**MOORSYDE WIND FARM
PLANNING AND
VISUAL IMPACT APPRAISAL**

**BERWICK-UPON-TWEED
BOROUGH COUNCIL**

REVISED DRAFT

November 2006

Plate 4: View south from Shoreswood, approximately 1km from the nearest turbine
note: most of the turbines will be openly and largely visible from this location

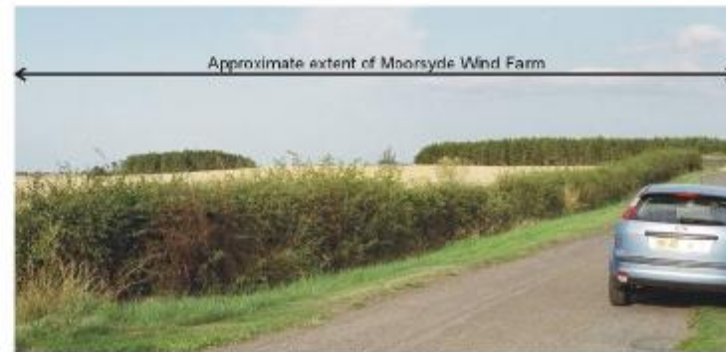
- View south from Shoreswood. This viewpoint is located halfway between viewpoint 2 and 3 of the original ES.
- This viewpoint shows a view of the proposed wind farm site from one of the closest settlements to the site. It is taken from a public road and there are a number of houses nearby. Photomontage viewpoints 2 and 3 from the original ES indicate adequately the nature of the visual impact on this area.

- View southwest from the pub at West Allerdeen (refer to Plate 1)
- View south from West Lodge (refer to Plate 8)
- View southeast from Hutton (refer to Plate 9)
- View southeast from Fouldon Viewpoint (refer to Plate 11)
- View southwest from Camphill Viewpoint or elevated location along the A1 (refer to Plate 12)
- View southwest from Scremerston (refer to Plate 15)
- View south from Shoreswood (refer to Plate 4)
- View east from Grievestead (refer to Plate 5)

Plate 13: View southwest from the A1 junction with the B6461, approximately 7.9km from the nearest turbine
note: the tips of the turbines may be distantly visible, depending on the weather conditions

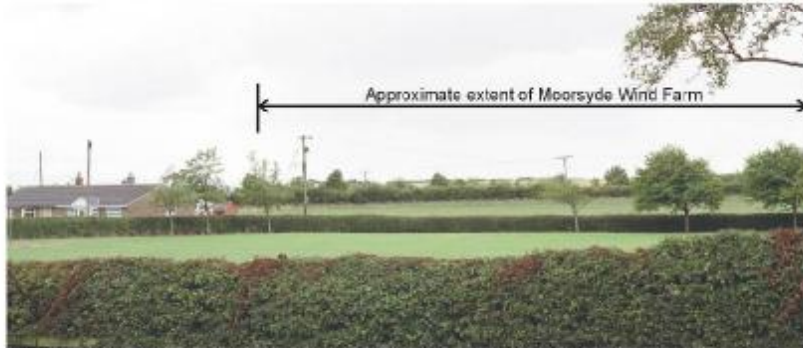
- Similar location to 'Viewpoint 4 BERWICK BYPASS (Fig 10.10)' of original ES.
- This is an unsuitable viewpoint, as the picture was taken from a very low elevation along the A1. Neither the site lands nor the Cheviot Hills are visible in this view, whereas these would be visible from more elevated locations along the A1.
- A photomontage would be more appropriate taken from further north along the A1 or from the Camphill Viewpoint (see Plate 12) instead.
